May 30, 2018

Mr. Peter Quackenbush, Senior Environmental Engineer
MDEQ – Office of Waste Management and Radiological Protection
525 West Allegan Street
Lansing, MI 48933

Subject: **Addendum to the Proposed Permit Modification - Upgrades to MC VI-G Phase 2 Liner Design, Wayne Disposal, Inc., Belleville, Wayne County, Michigan**

TOP OF PRIMARY LINER GRADING PLAN (2 OF 3)

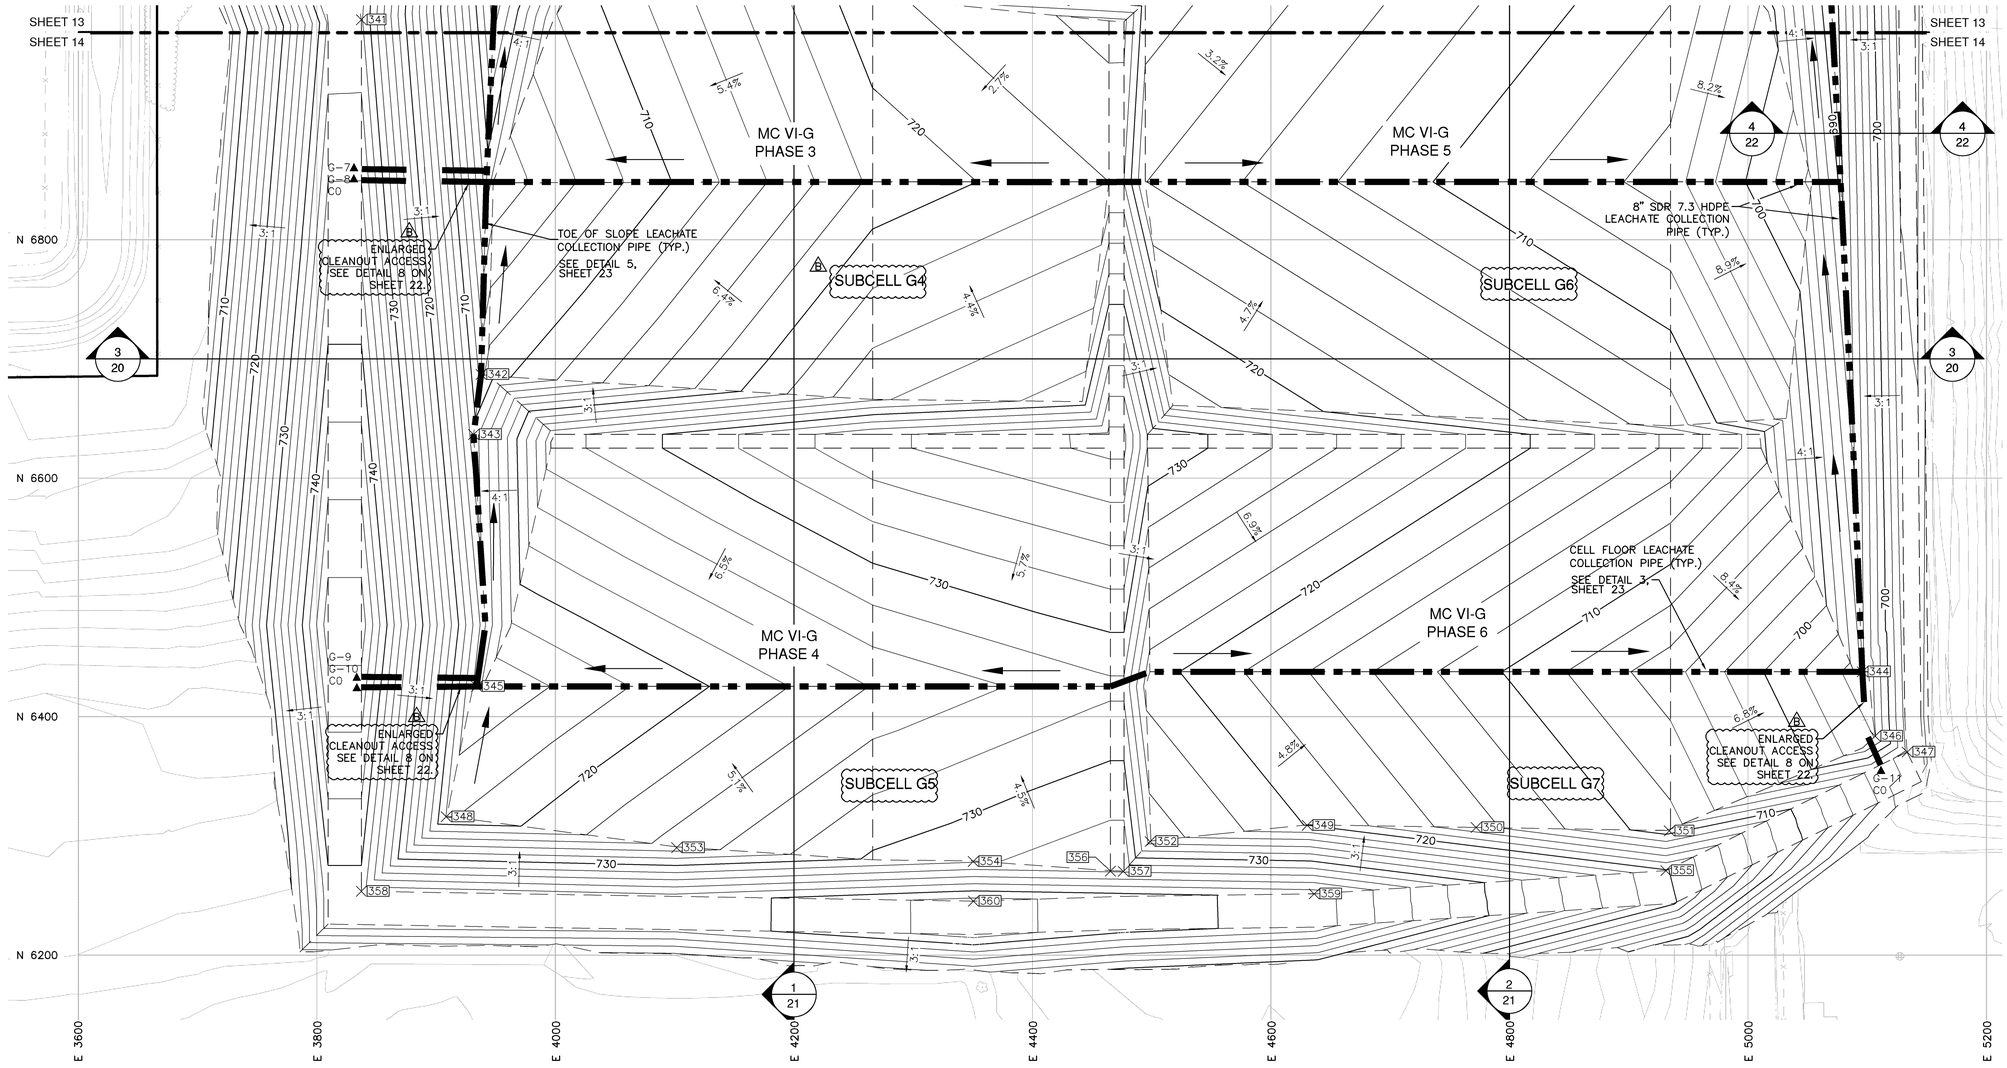
Additionally, the following sheets in the submitted 2018 Permit Engineering Drawings have been revised to reflect the proposed SDR changes (denoted as Revision "E" in **Attachment A-2**):

- TITLE SHEET
- SHEET 13 – TOP OF PRIMARY LINER GRADING PLAN (2 OF 3)
- SHEET 22A – LINER SYSTEM DETAILS
- SHEET 23A (NEW SHEET) – LEACHATE COLLECTION SYSTEM DETAILS (FOR MC VI-G SUBCELL G2 AND G3)
